June 12, 2025

ADDENDUM NO. 4

PROJECT TITLE
**PGA GOLF MANAGEMENT PROGRAM
ACADEMIC LEARNING LAB CONSTRUCTION**
COASTAL CAROLINA UNIVERSITY
107 CITADEL DR. CONWAY, SC 29526

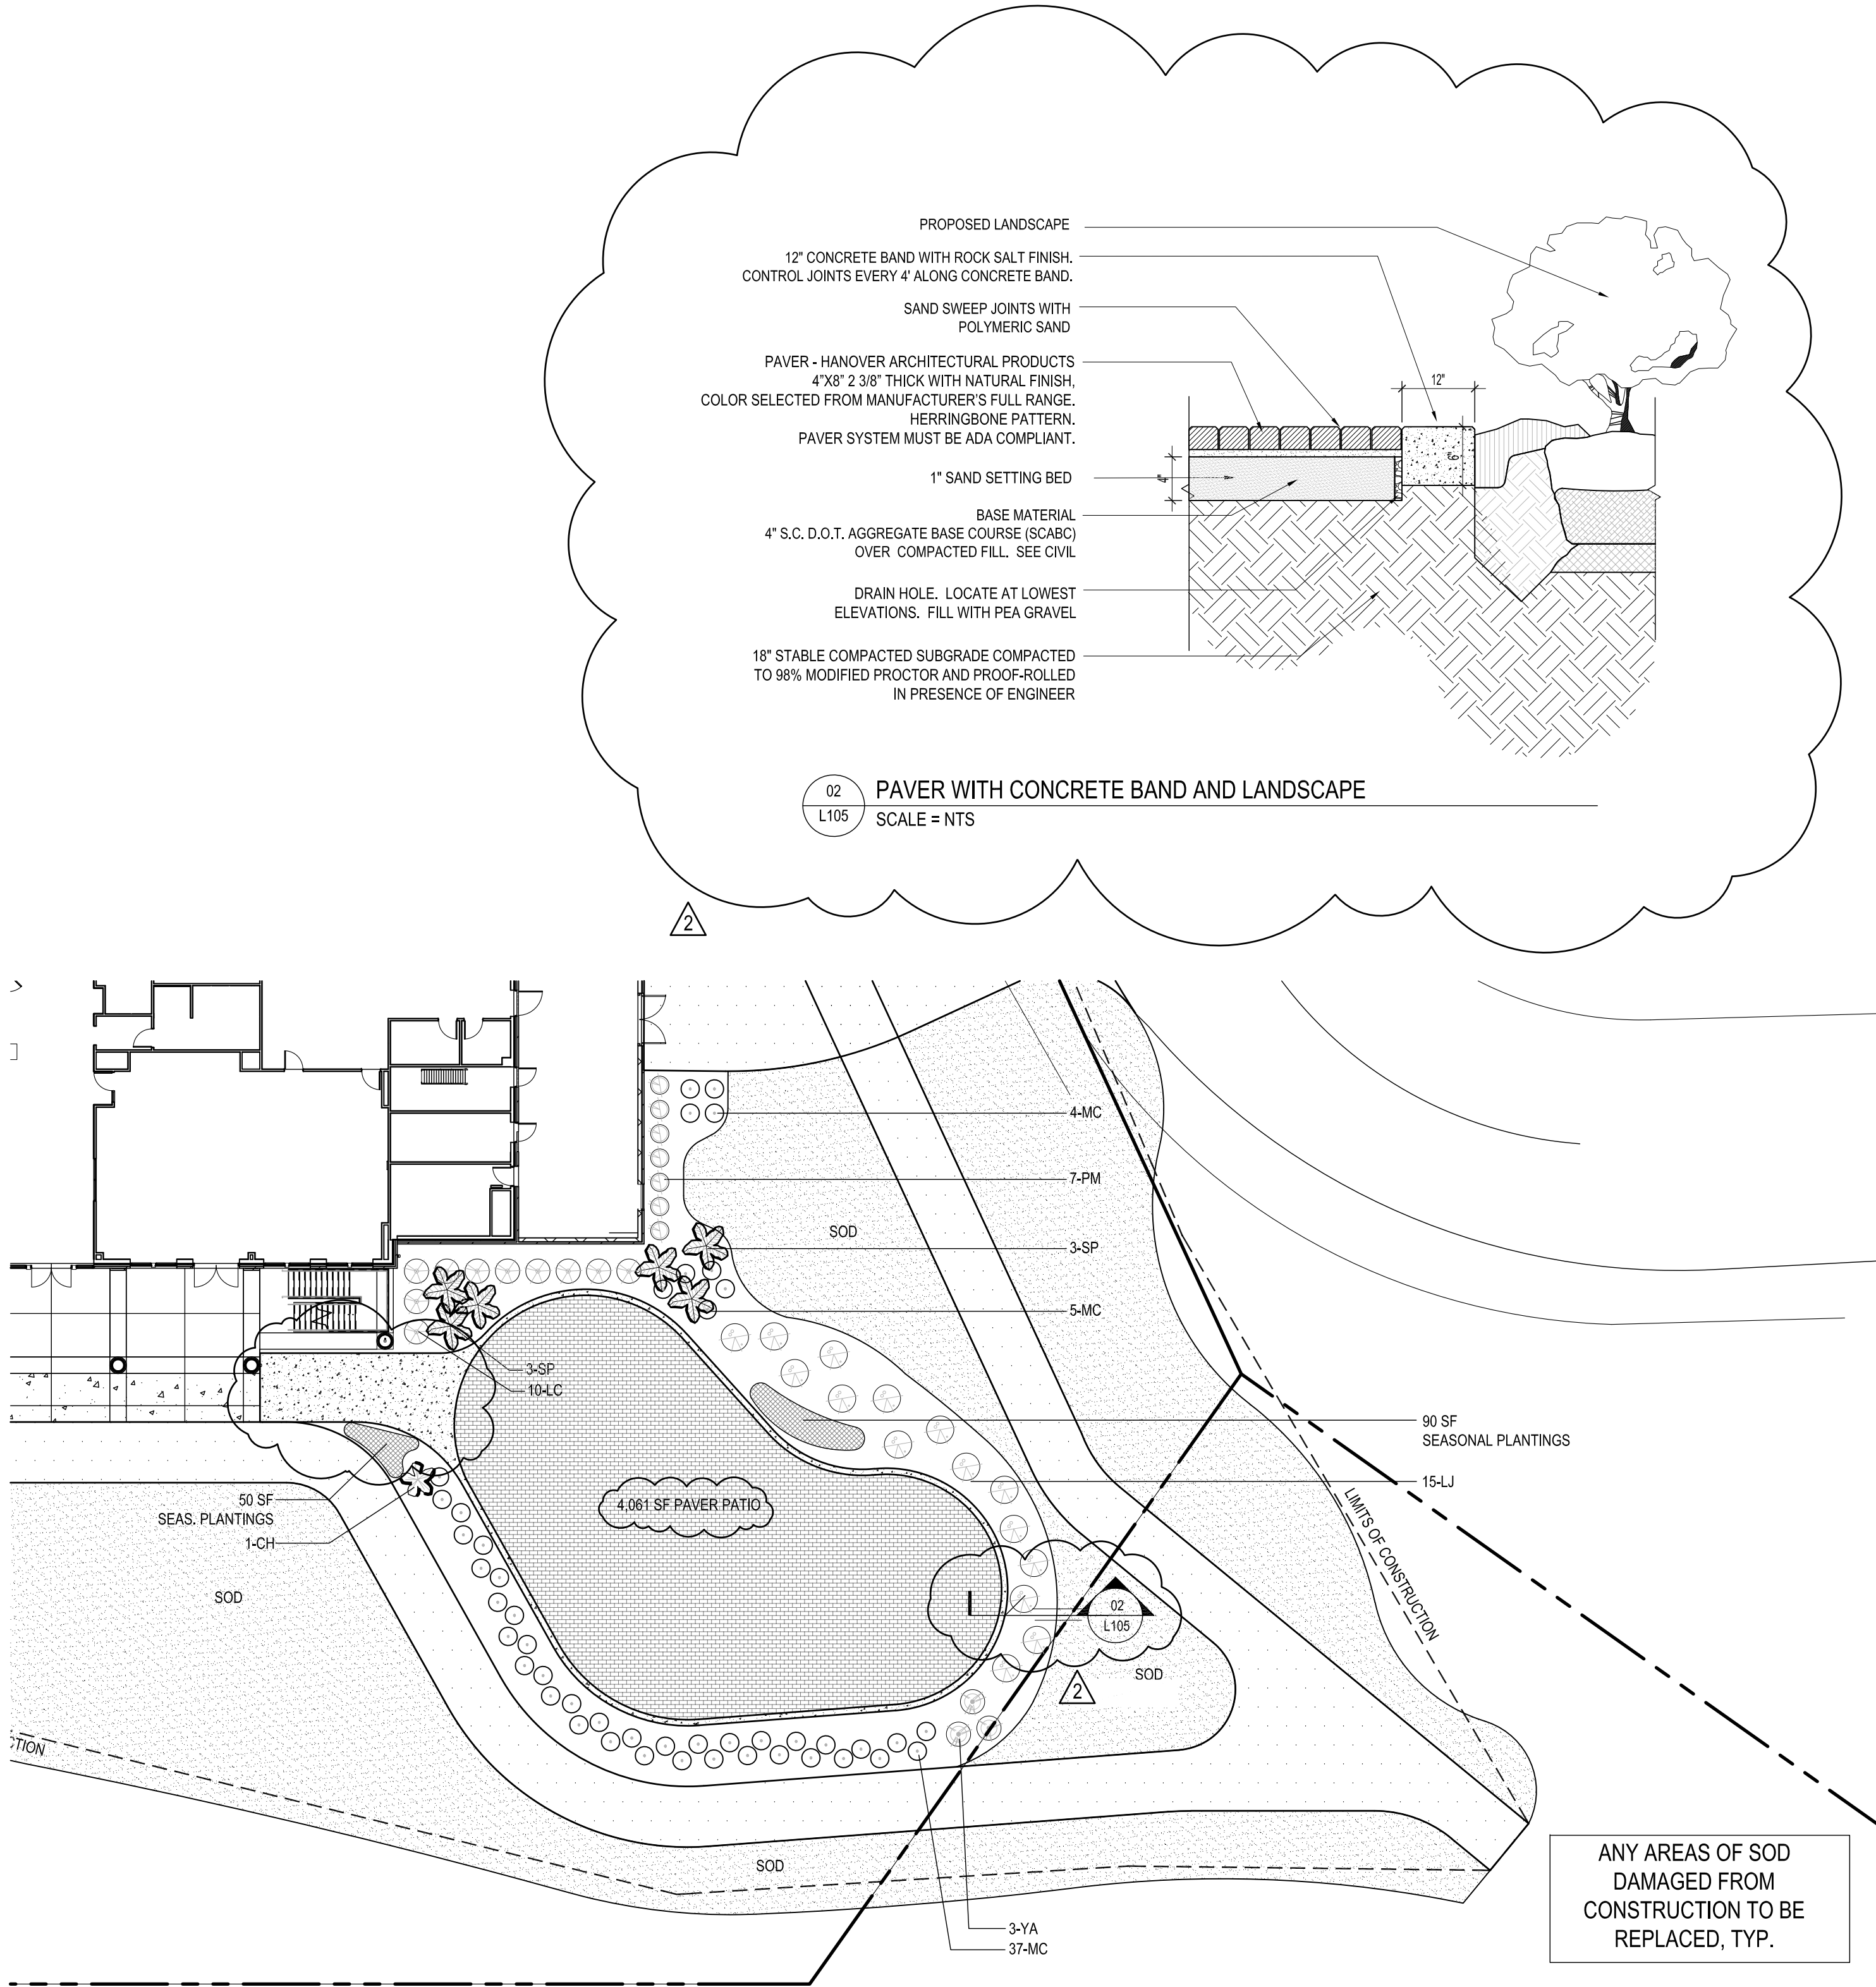
| 4-1 | Sheet L105 – ADD ALTERNATE #1 PATIO LANDSCAPE PLAN (Drawings reissued): <ol style="list-style-type: none">a) Plant list revised showing only the landscape quantities related to the add alternate. |

SHEET NO.
S-200

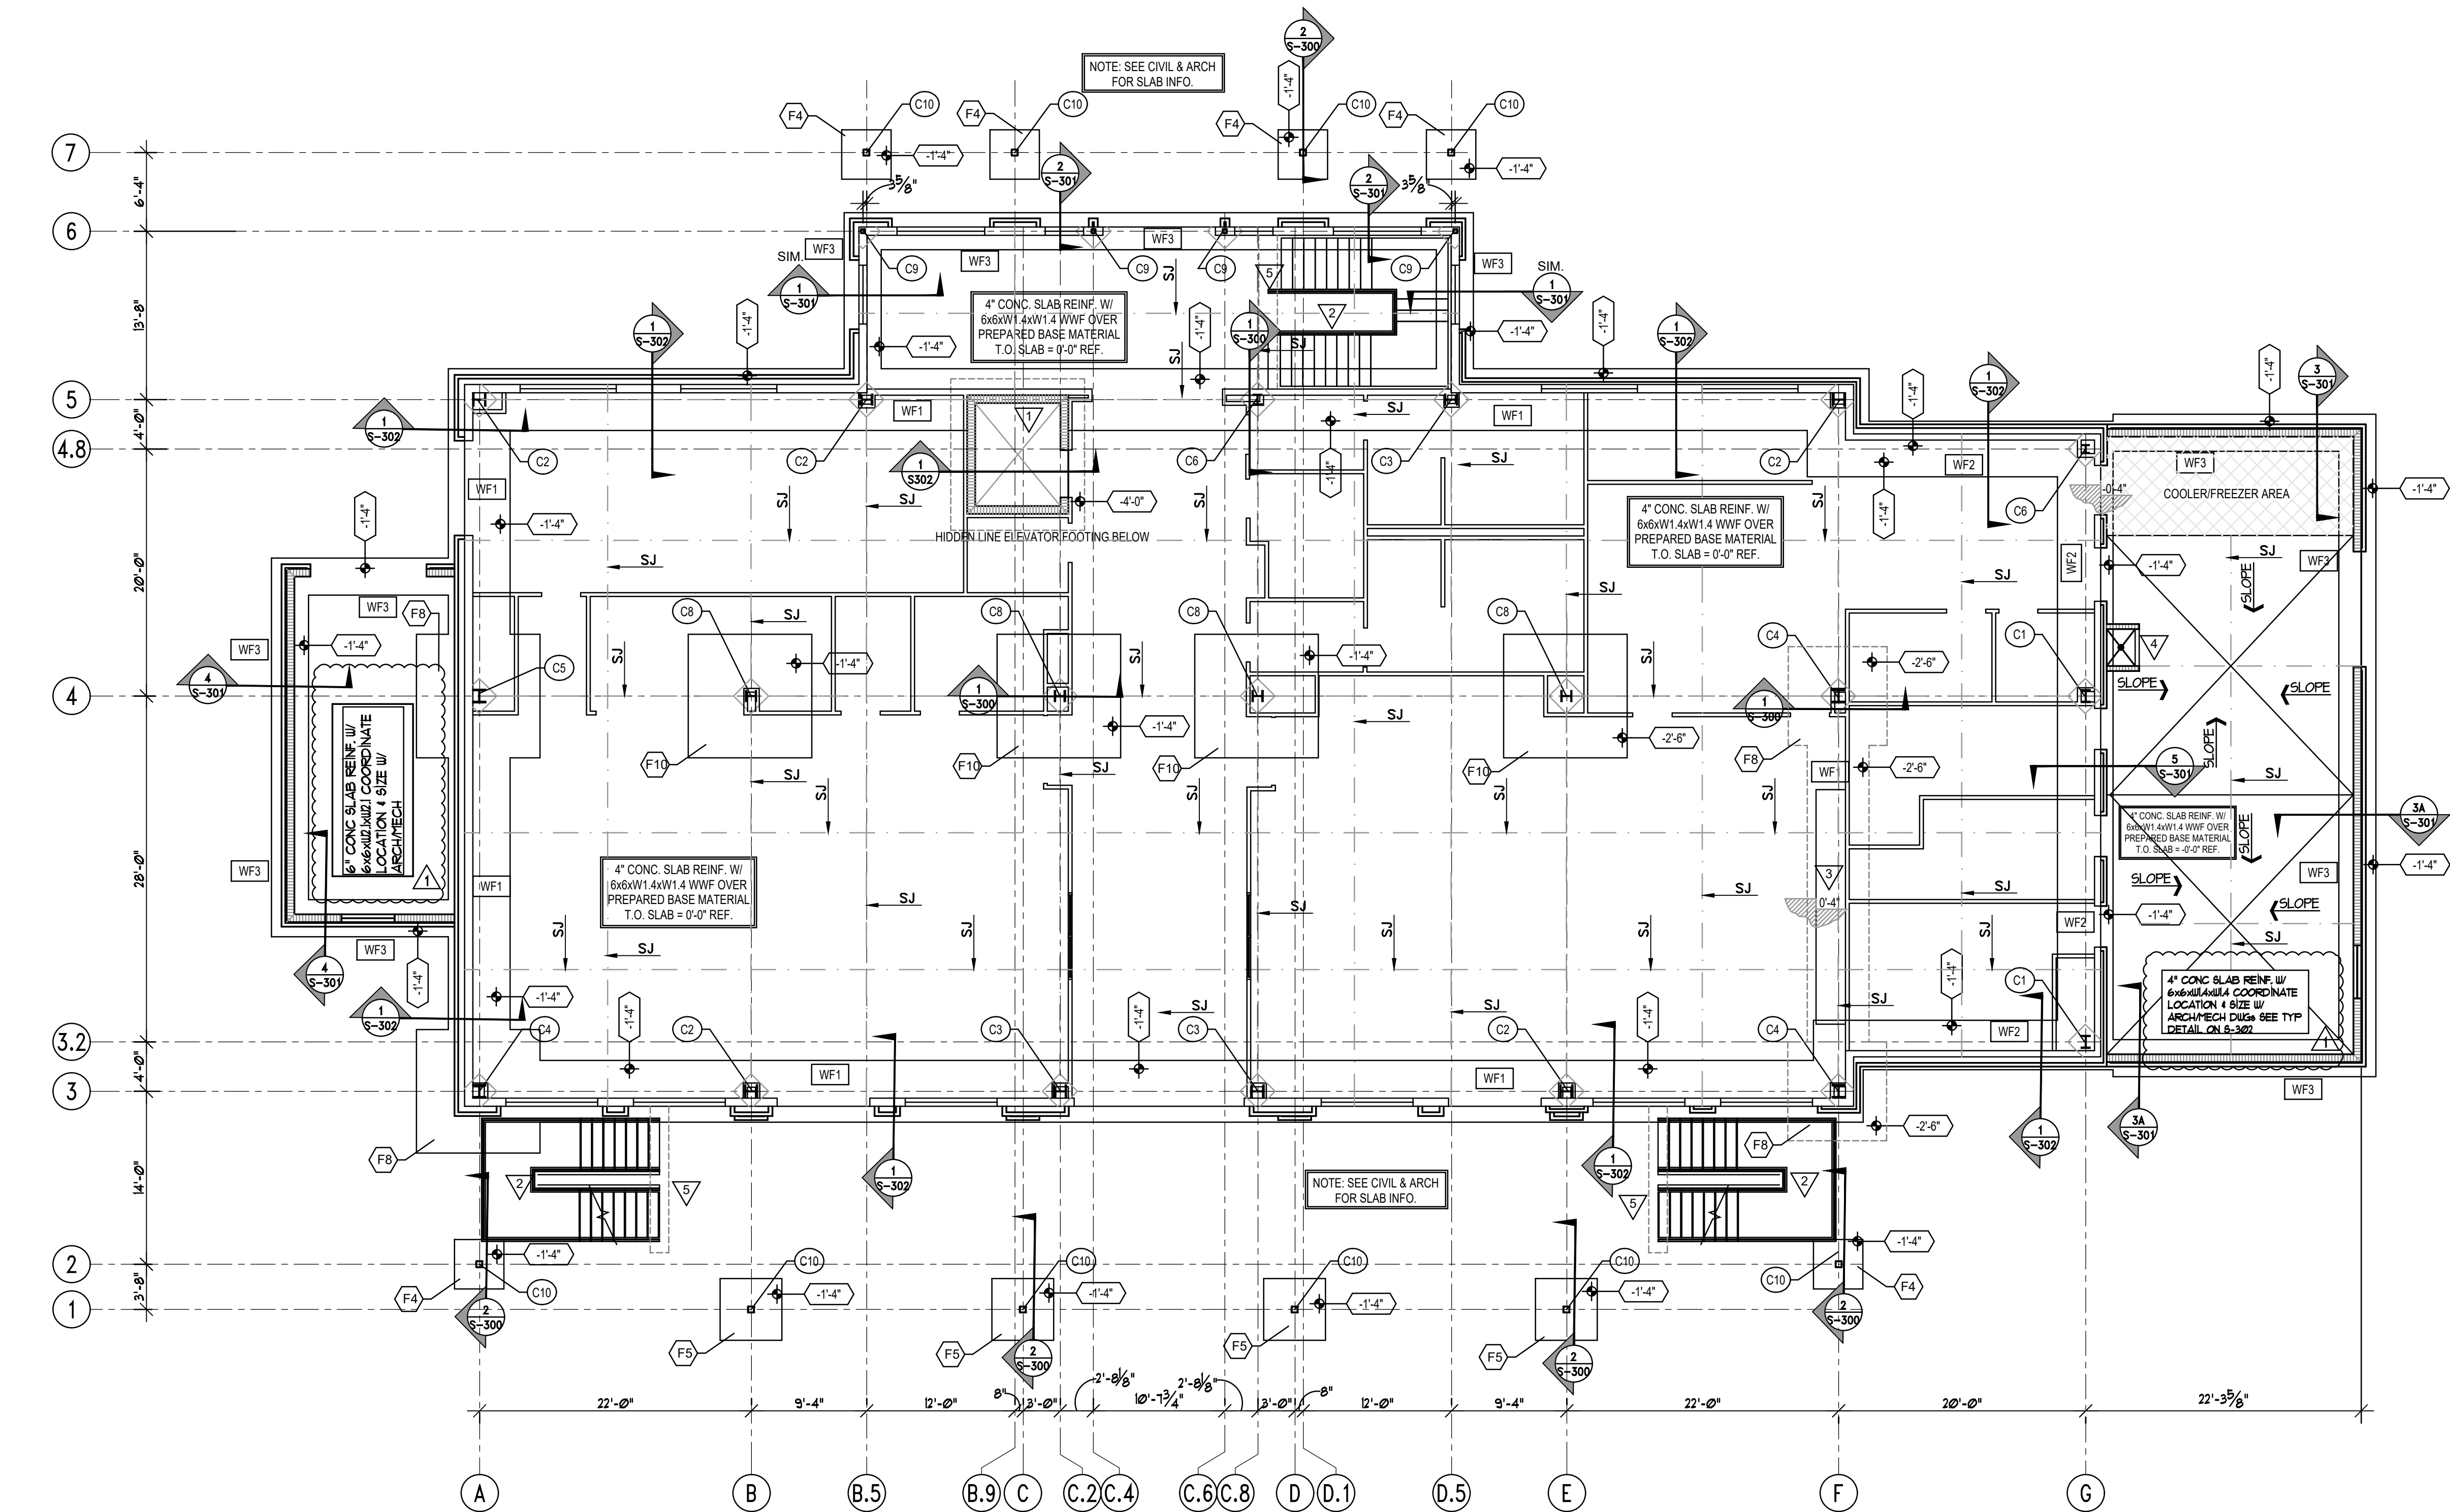
- 4-2 Sheet S-200 – FOUNDATION PLAN (Drawings reissued):
 - a) Drawing reissued to clarify the mechanical pads.
- 4-3 Sheet S-302 – DETAILS (Drawings reissued):

TYPICAL MECH PAD DETAIL
NO SCALE

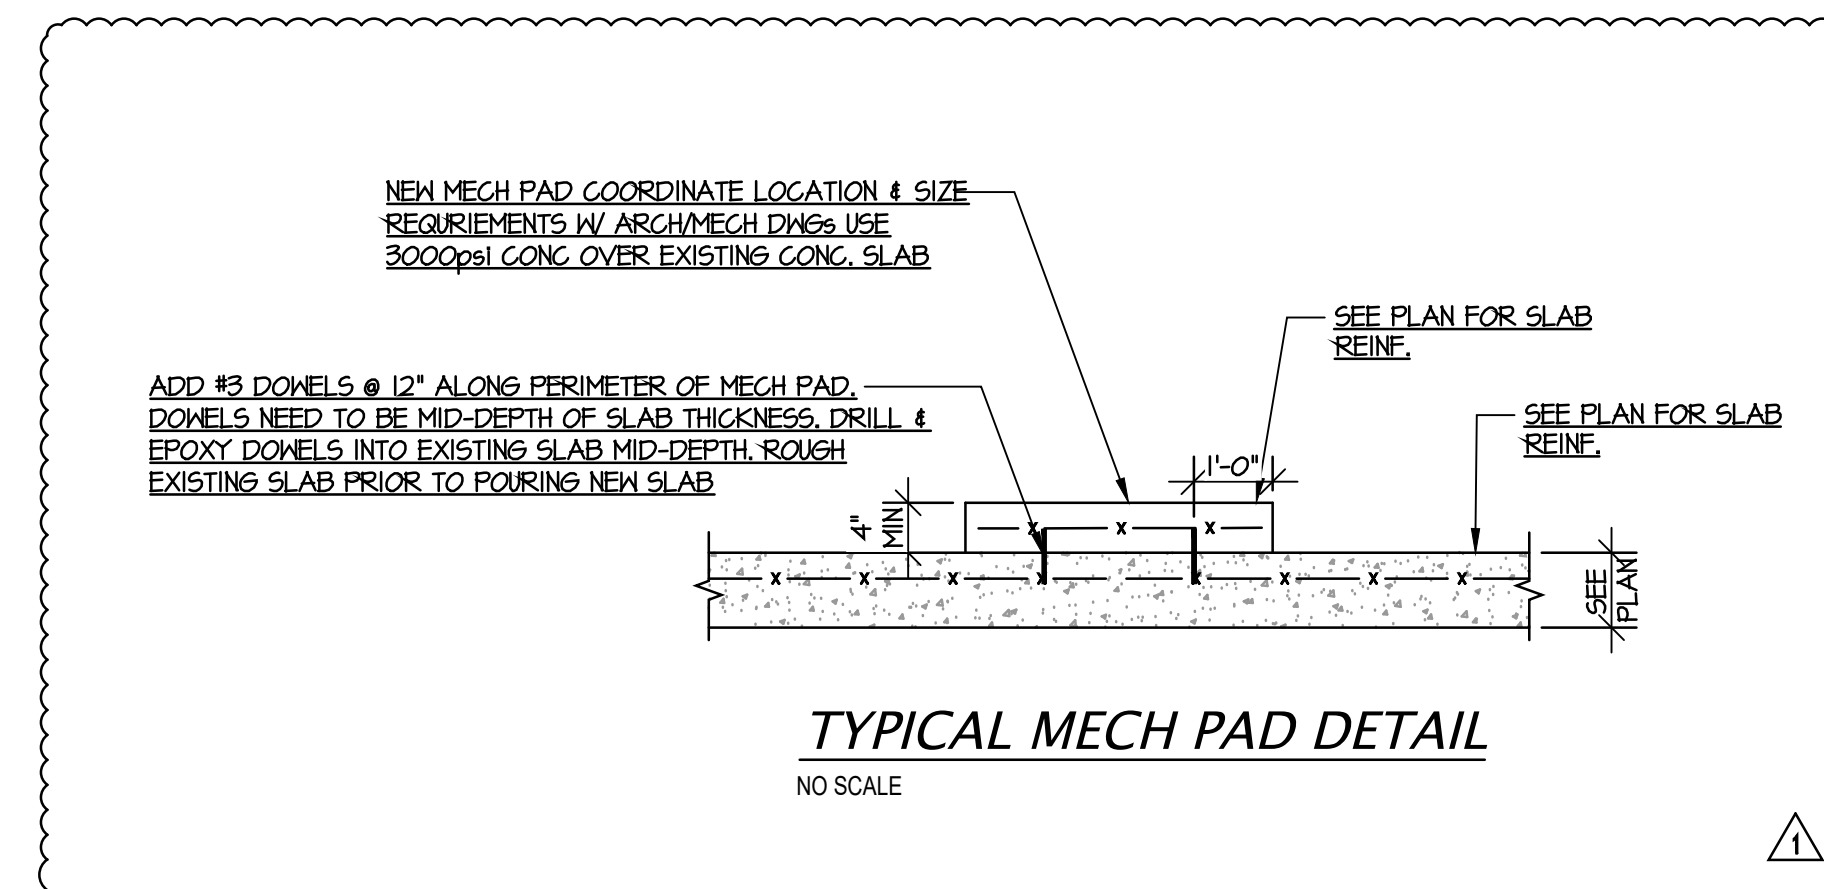
- a) Drawing reissued to include typical mechanical pad detail
- 4-4 Sheet E-201 – ELECTRICAL LIGHTING PLAN – FIRST FLOOR (Drawings not reissued):
 - a) Provide a combination occupancy and daylight sensor in the device in Lobby L100.
